PROPOSED GRANGE TO SEMAPHORE PARK LINEAR PARK

Stage I: North

CONSULTATION REPORT

September 2020

Artistic impression of proposed Coast Park

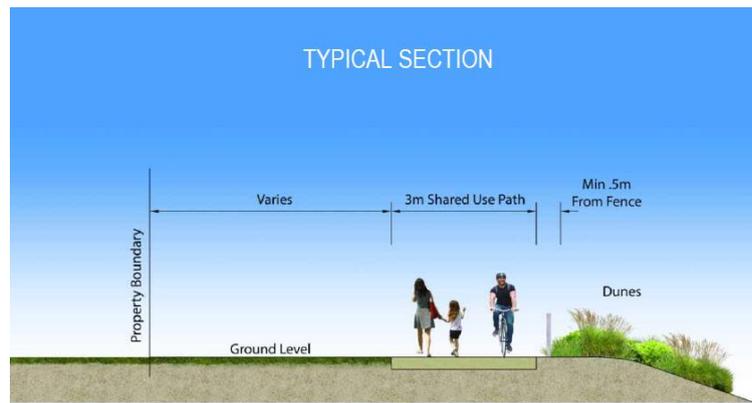
For those respondents who provided a comment on the pathway material, only 16% support the proposed material, while the other 84% have requested some form of changes. These requests include:

- construction of a compacted, crushed rubble path (similar to the Tennyson Dunes Discovery Trail)
- construction of a shared-use path using a mixture of concrete and boardwalk
- no change to the current environment with a preference to keep the existing grass.

"I am concerned about the lack of design consideration which comes with designing a shared path. In the artistic imagery provided, it appears to be non-existent. A multi-million dollar asset should not be boring ..., yet as we know typical SA infrastructural projects are executed on a shoestring budget and sometimes appear to have little vision as a long-term asset to the community and State of South Australia. ... the stretch just completed in front of Minda holds a credible level of detail and design, will age well and is an actual asset for the State."

The proposed material (i.e. sandy coloured concrete aggregate) is consistent with other sections of the Coast Park shared-use pathway within the City of Charles Sturt and other council areas.

The Objects of the Act include the promotion of the use and enjoyment of linear parks by members of the community. It is therefore important that the materials used for the shared-use pathway are smooth, skid resistant, dust-free, waterproof and durable. This will allow all types of users to access this pathway, including users of mobility devices, people with prams, people walking and people riding. In addition, the surface will visually enhance the surrounding environment through sympathetic material colour choice by using a sandy coloured concrete.

The materials chosen will also need to be consistent with requirements of shared-use pathways in accordance with Austroads Technical Standards - Part 6A Pedestrian and Cyclist Paths. **For this reason no change to the material choice is recommended.**
